Project Name: Rattail Project
Responsible Official: Forest Supervisor Ted McArther
Six Rivers National Forest

RE: Objection to the Rattail Project

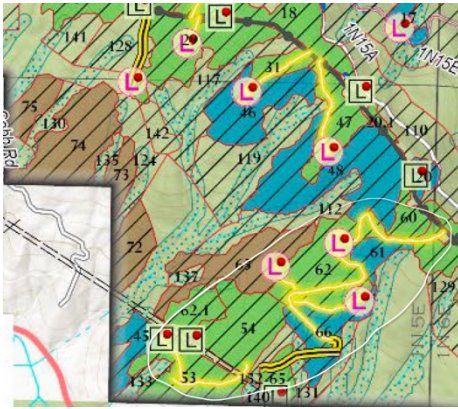
The EA, Draft Decision and Response to Comments, did not provide detail as to why limiting the segment, of nearly 2 miles of road and three new landing construction sites, starting in Unit 60 (circled in white in image to the left) was not analyzed.

Despite being a main factor of concern and reasoning, the EA and supporting documents do not provide any discussion on economics. How much will this significant and extreme road building and landing construction cost, with all the cut and fill needed to allow 18-wheeler access on these *steep* slopes? How much will sub-soiling and ripping (as the EA and Draft Decision Notice assure and relevant effects analysis are based on this occurring) this segment of road cost?

We argue that the amount of disturbance of enlarging two existing landings, as stated on page 23-24 of the Final EA, is vastly less disturbance than using heavy equipment and bulldozers with an undisclosed amount of cut and fill on nearly two miles of roads, between 15 and 25 feet wide, and at least three new landings on previously undisturbed *steep* slopes in the Eel River Late Successional Reserve.

Diminish the level of road and landing construction on this slope. This could include expanding helicopter systems. Or supplement the EA with: a detailed economic cost analysis and comparison; safety and disturbance comparisons and; provide an explanation of why certain units were excluded from helicopter logging but others were not.
